Docket Item # 7 & 8  
BAR CASE # 2010-0061/0062

BAR Meeting  
May 5, 2010

**ISSUE:** Permit to Encapsulate & Addition

**LOCATION:** 907 South Saint Asaph Street

Figure 1: : Survey of 907 South St. Asaph Street, with new porch shown.

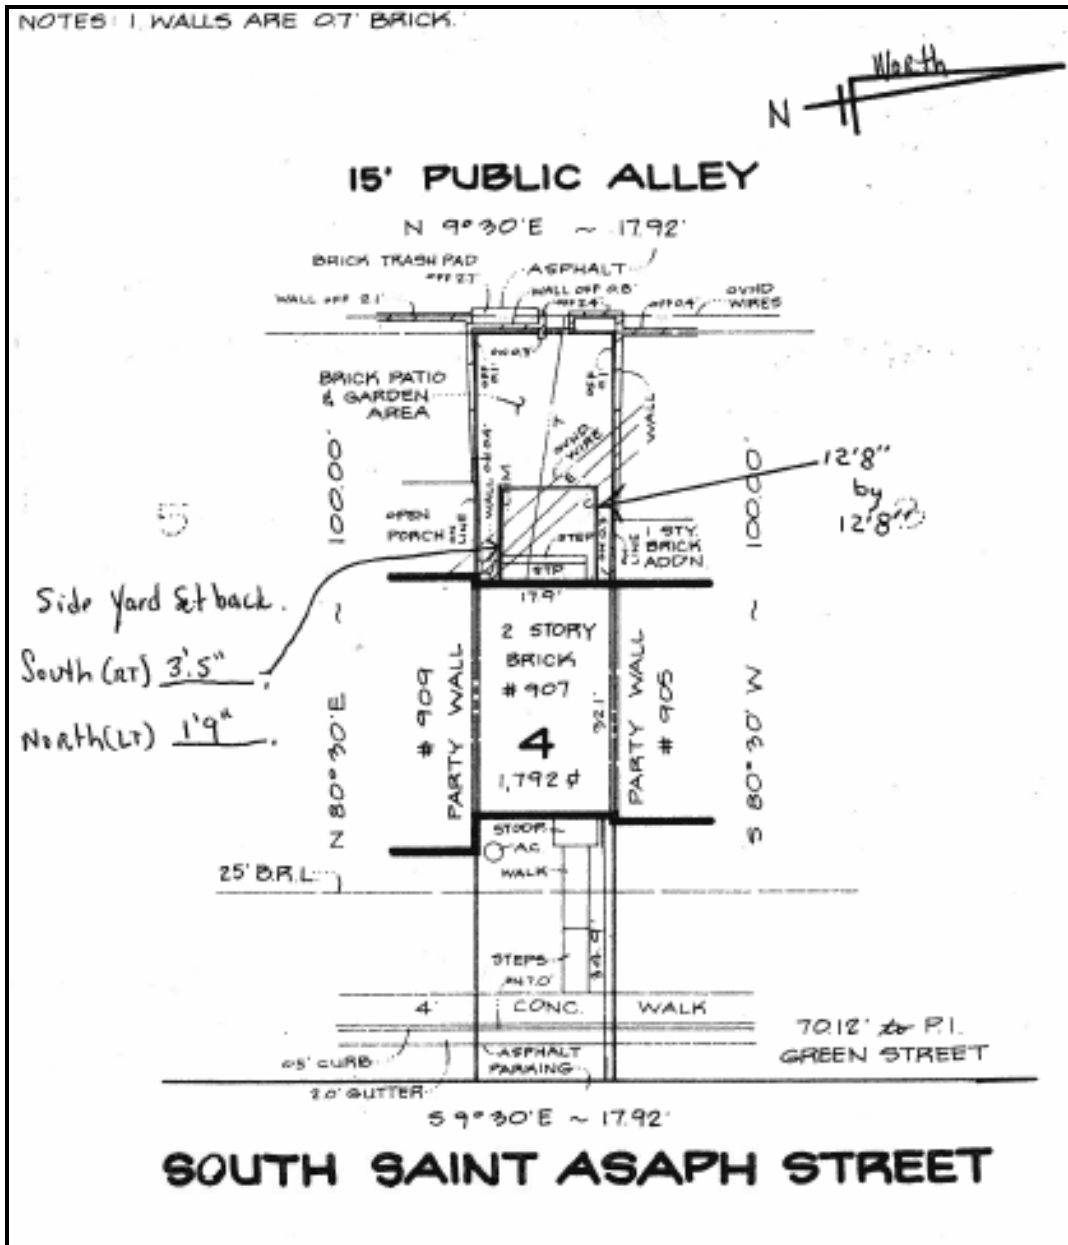
The proposed enclosed porch complies with the RM zone as defined in the City's Zoning Ordinance. The RM zone requires that the lot provide a minimum of 35% open space or 627.2 sq ft. The lot currently provides 1159.41 sq ft or nearly 64% open space, and will provide 994.57 sq ft or 55% open space after construction of the proposed porch.

Figure 2: View of the Rear Elevation of Proposed Addition

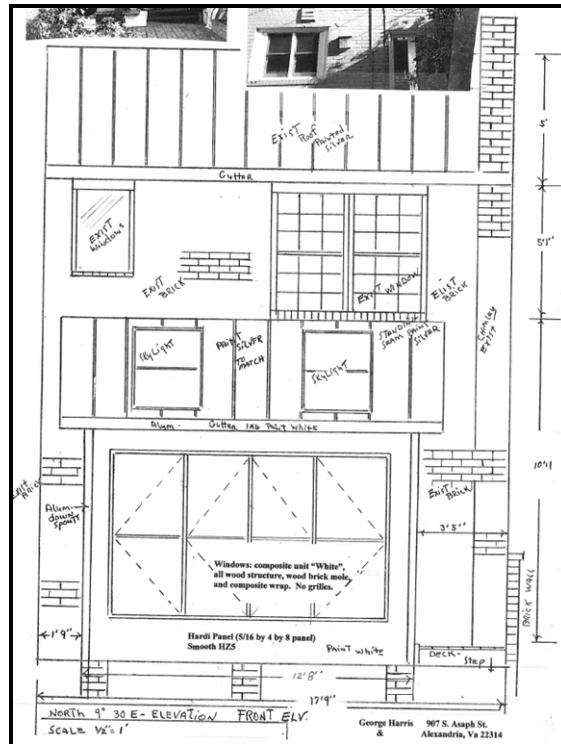
The applicant also proposes to install diagonal lattice under the porch. Staff recommends that the

lattice be constructed in a horizontal and vertical configuration, rather than diagonally as horizontal and vertical lattice is the more typical historic lattice configuration in the district and the configuration referenced in the *Guidelines* and that the Board generally approves. Staff is including this as a suggestion rather than a condition since it appears that the lattice will not be visible from the public right-of-way over the existing brick garden wall fence and solid wood gate.

While single-glazed, true-divided-light, double hung wood windows are preferable, and wood composite windows are discouraged window types in the *Design Guidelines*, the Board generally is more flexible on elements of projects which are not visible from the public right-of-way. Staff finds that the proposed windows and doors are appropriate if the specifications include simulated-divided lights. Additionally, it is recommended the windows and doors contain the 7/8" width muntins. This window detail provides the appropriate specification for new construction within the boundaries of the historic district. Staff has also included the standard condition that exterior wood features, such as the steps, be painted or stained.

1. That all of the wood surfaces on the proposed wood entry staircase be painted or stained; and,
2. That the new windows be simulated, divided light, wood composite windows, which contain 7/8" muntins that are permanently bonded to the interior and exterior of the insulating glass simulating a divided light appearance, with manufacturer specification cut sheets to be submitted to Staff for review and approval prior to filing for a building permit.
